Standards Committee

Meeting Agenda

TITLE	Champion
<p>1st time to Committee. Twenty (20) proposed drawings and revisions to WVDOH Standard details Book – Volume 2. The sheets are listed below. A summary of each sheets revisions are included in the meeting packet; and proposed sheets have revised areas highlighted yellow.</p> <ul style="list-style-type: none"> a) <i>TE1-3A Roadside Sign Supports Steel Beam Type</i> b) <i>TE1-3B Roadside Sign Supports Steel Beam Type</i> c) <i>TE1-3C Roadside Sign Supports Steel Beam Type</i> d) <i>TE2-1A Bridge or Retaining Wall Sign Mounting, Type K 1 & 2 Supports</i> e) <i>TE2-1B Bridge or Retaining Wall Sign Mounting, Type K 1 & 2 Supports</i> f) <i>TE2-2 Bridge or Retaining Wall Sign Mounting, Type L Pipe Post Mount</i> g) <i>TE2-3 Barrier Wall Sign Support Bracket Type D</i> h) <i>TE3-1 Overhead Sign Support – Steel Two Tube Span (TTS)</i> i) <i>TE3-2 Overhead Sign Support – Steel One Tube Span (OTS)</i> j) <i>TE4-3A Overhead Sign Support – Steel Double Arm Cantilever</i> k) <i>TE4-3B Overhead Sign Support – Butterfly Cantilever</i> l) <i>TE4-4A Overhead Sign Support – Single Arm Cantilever (Heavy)</i> m) <i>TE4-4B Overhead Sign Support – Sing

OVERHEAD SIGN SUPPORT-STEEL
SINGLE ARM CANTILEVER (LIGHT)
STANDARD SHEET TE4-4B

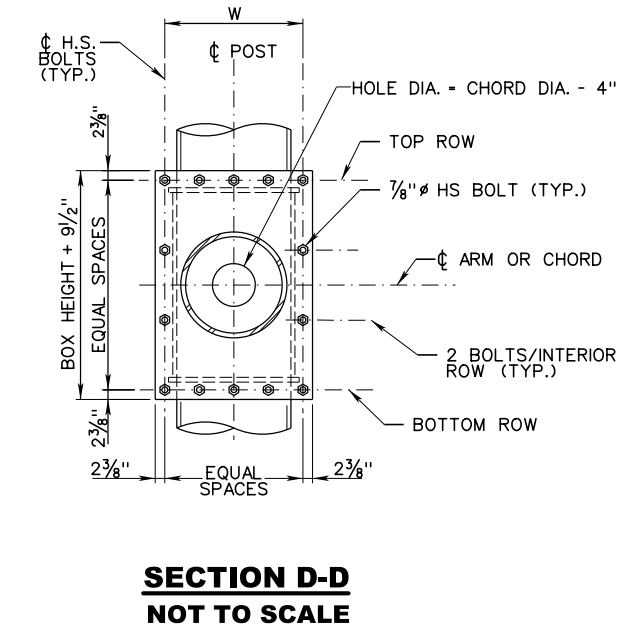
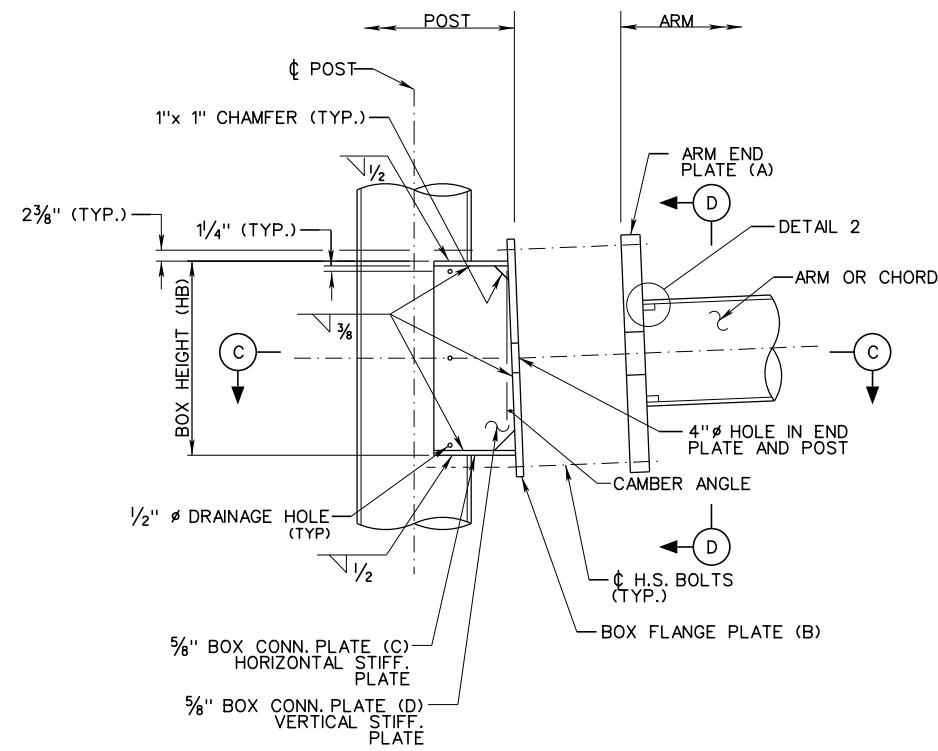
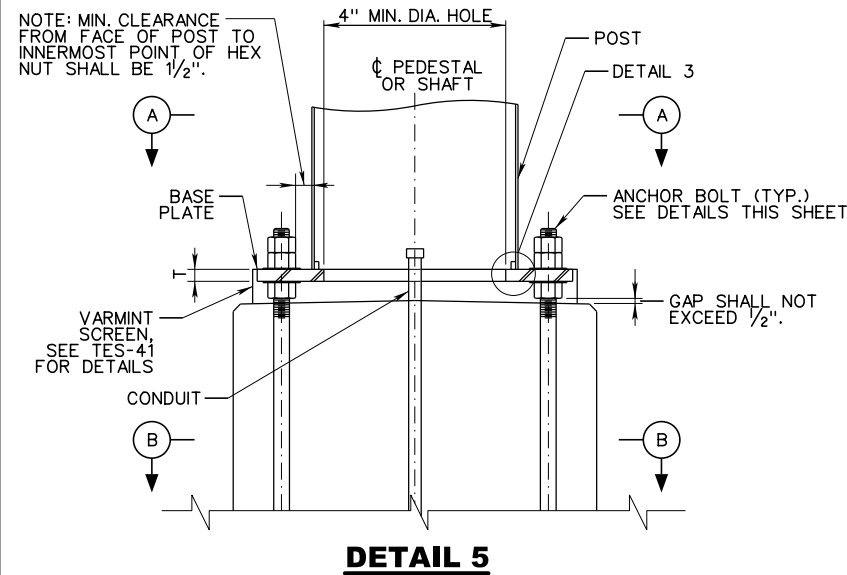
ADDED MOMENT ARM CALCULATION, REVISED PLATE HOLE DIAMETER, ADDED W DIMENSION TO TABLE, ADDED CAMBER ANGLE.
 REVISED ARM SIZES.

STANDARD SHEET TE4-5

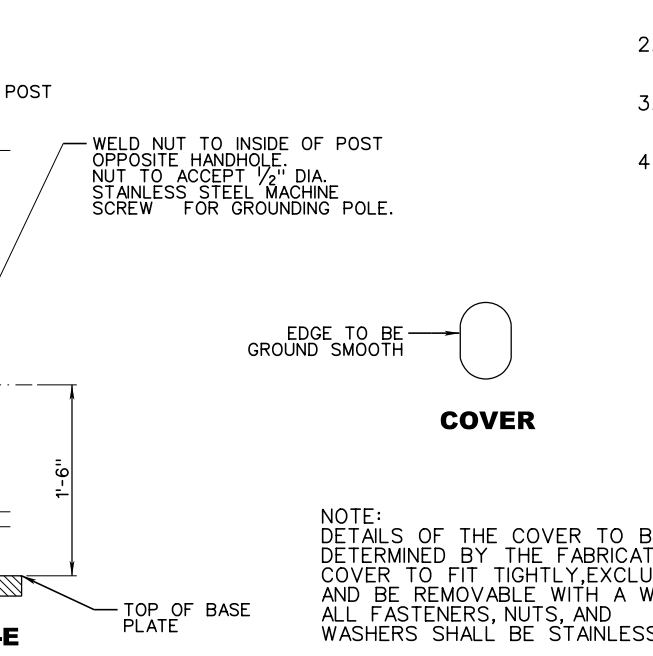
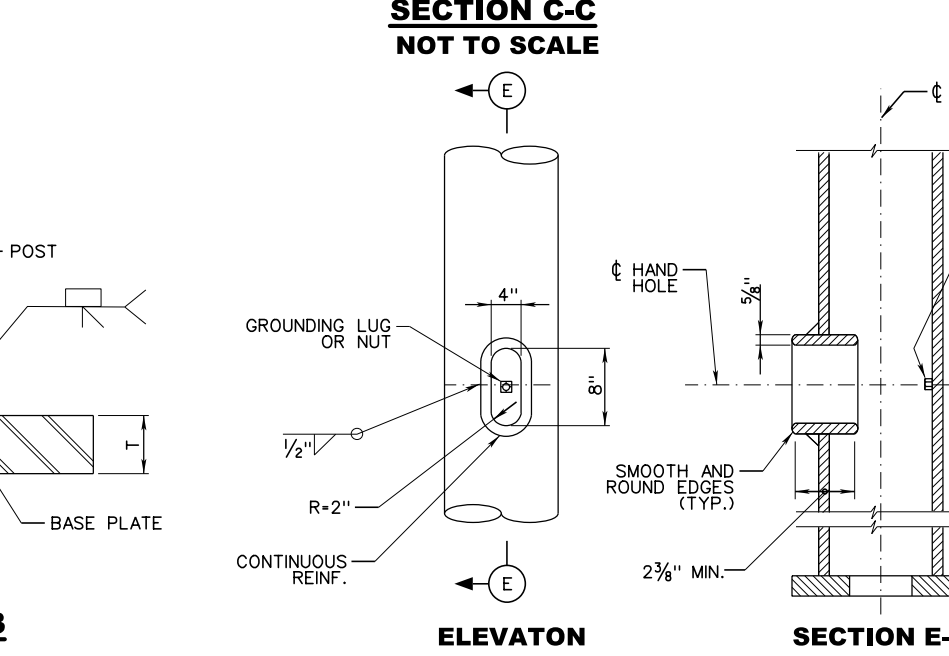
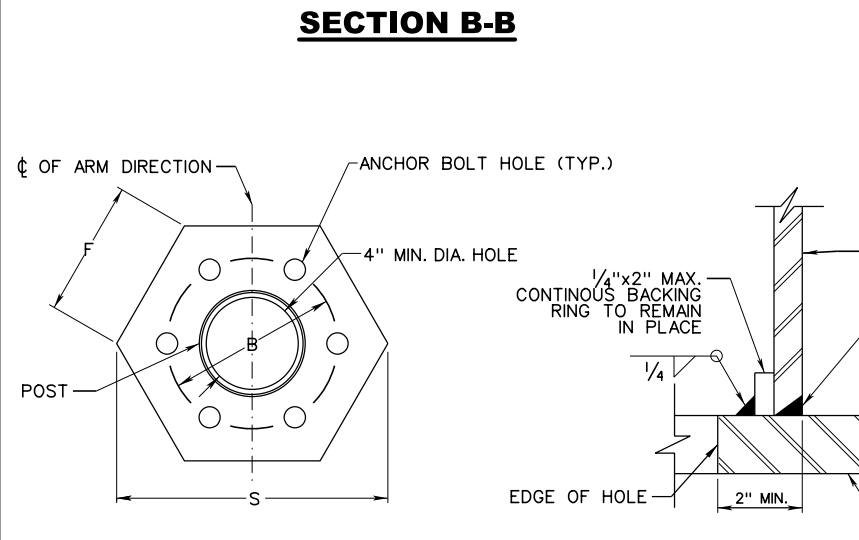
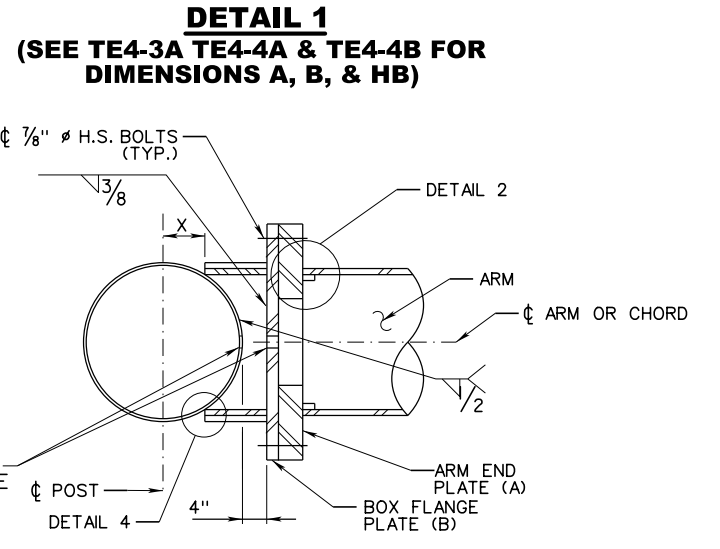
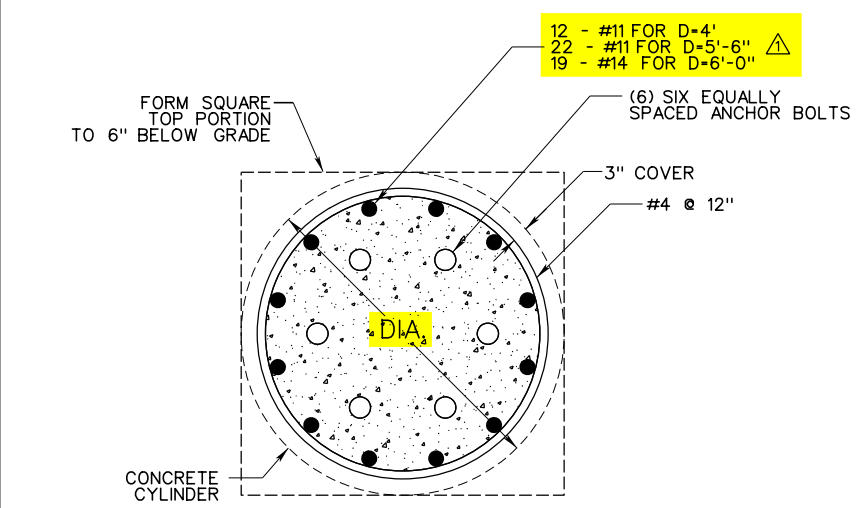
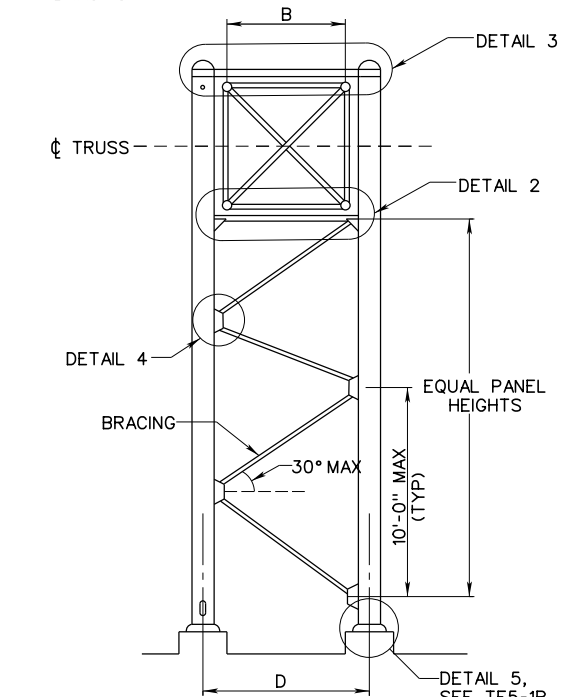
REVISOR: REVISED REINFORCING BASED ON FOOTING SIZE CHANGES ON TE4-4A

STANDARD SHEET TE9-1

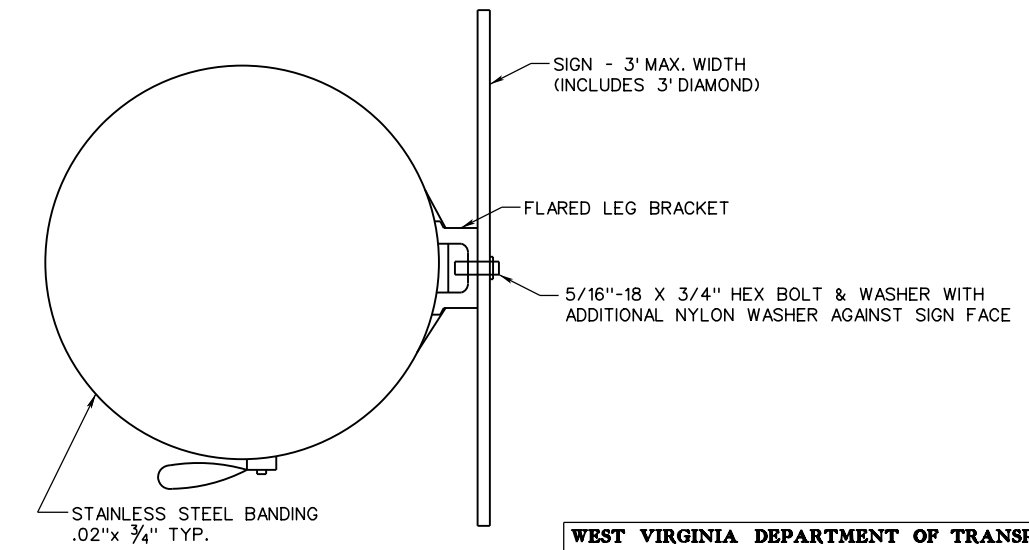
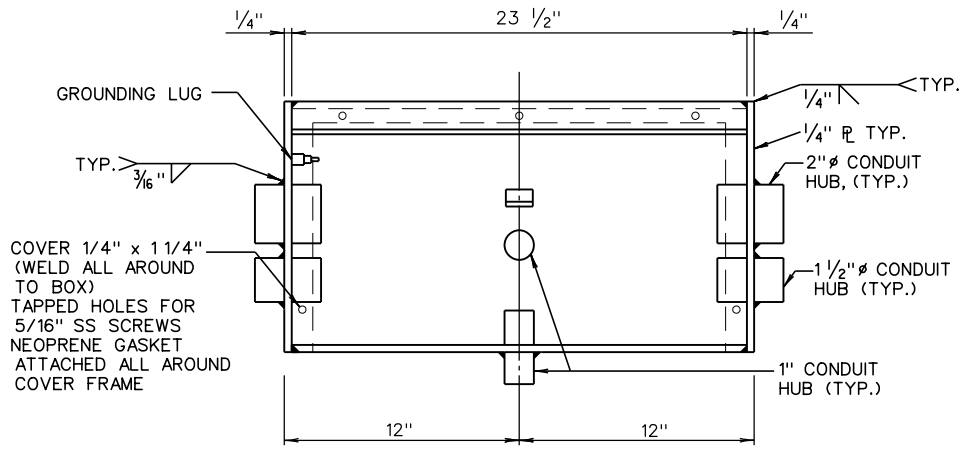
ADDED SADDLE TO U-BOLTS
